Land Development Review Division (619) 446-5460 FINAL RECIRCULATED ENVIRONMENTAL IMPACT REPORT

Project No. 2982 SCH No. 1999071104

SUBJECT: El Camino Real Road Bridge: SITE DEVELOPMENT PERMIT (SDP) for the road modifications to a segment of El Camino Real that runs from Via de la Valle to the north to San Dieguito Road to the south. This portion of El Camino Real is approximately 2,400 feet long, 23 feet wide, has one travel lane in each direction, and has no shoulders, bike lanes, or pedestrian walkways. The road segment includes a bridge over the San Dieguito River that is 340 feet long and 27 feet wide (24 feet wide curb to curb on the concrete travel surface, with 1.5-foot-wide raised concrete curbs on each side). The City proposes to modify the segment of El Camino Real between Via de la Valle and San Dieguito Road and replace the bridge in order to improve the structural integrity of the bridge over the San Dieguito River, alleviate problems associated with high flood events, improve pedestrian and vehicular access to nearby coastal and recreational resources, relieve traffic congestion, and improve consistency with the adopted land use plan and adopted Circulation Element

•	
	El Comino Pool
	El Camino Real
	Road/Bridge Widening
	Intersection Lane Configuration at
	Intersection Lane Configuration at Via de la Valle
	(Roundabout)
	Figure
m.	JOB NO. 1772 FILE: <u>Pre +174p</u> 2 - 17

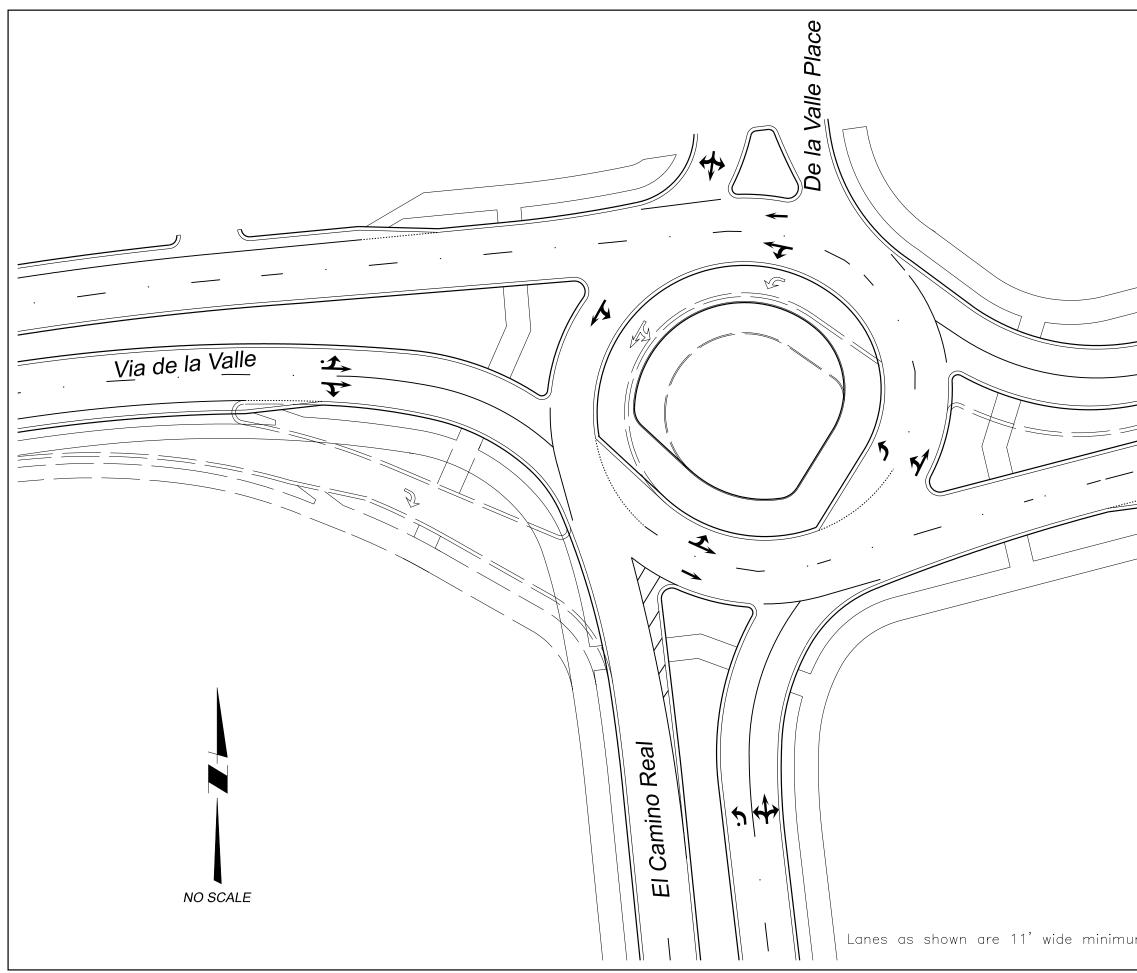
(February 1 to September 30), while Figures 2-24 through 2-29 define the nesting season as February 16 D-12 to September 15. Please correct the nesting season in Figures 2-24 through 2-29 to February 1 to September 30. Page 3.1-74. Section 3.1.5 (Mitigation Measure) should have specific measures to address each of the MSCP Land Use Adjacency Guidelines, as opposed to only the language from section 1.4.3 of the City's SAP. For example, as discussed elsewhere in the RDEIR, "drainage from the widened roadway would be routed to bio swales, hydrodynamic separators, or other appropriate permanent best management practices constructed between the widened roadway and the existing or restored open ditch, and these facilities would serve to treat runoff prior to the runoff entering the San Dieguito River." Page 3.7-1. Section 3.7 (Hydrology/Water Quality). In order to determine whether the updated hydrologic and hydraulic studies sufficiently addressed the concerns expressed in our 2006 letter, the Department's	 permits from the applicable agencies. Similar to the proposed project, any future trails would be required to avoid and minimize impacts to MHPA and wetland resources to the extent feasible. It is not clear what trail on page 3.1-42 of the Draft EIR is being referenced in this comment. If the comment is referring to JPA trail Segments 11 and 12 discussed on page 3.1-38 of the Draft EIR, please see JPA comment #12, which notes: "8. The DEIR does not correctly describe the current condition of the Coast to Crest Trail in the project area. The DEIR does not identify the fact that the Coast to Crest Trail Horse Park segment currently exists and dead ends at El Camino Real. Page 3.1-4 under "Project Site Land Uses" should include that trail segment. The statement in Section 3.3.2.6 (end of first paragraph) needs to be updated to reflect the fact that the CTC Trail now exists along the entire southern edge of Horse Park to El Camino Real." These corrections have been made in the Final EIR. The only public trail segments incorporated into this project are the undercrossing that will be set under the north bridge abutment,

- D-12 Figures 2-24 through 2-29 have been revised as requested in the Final EIR.
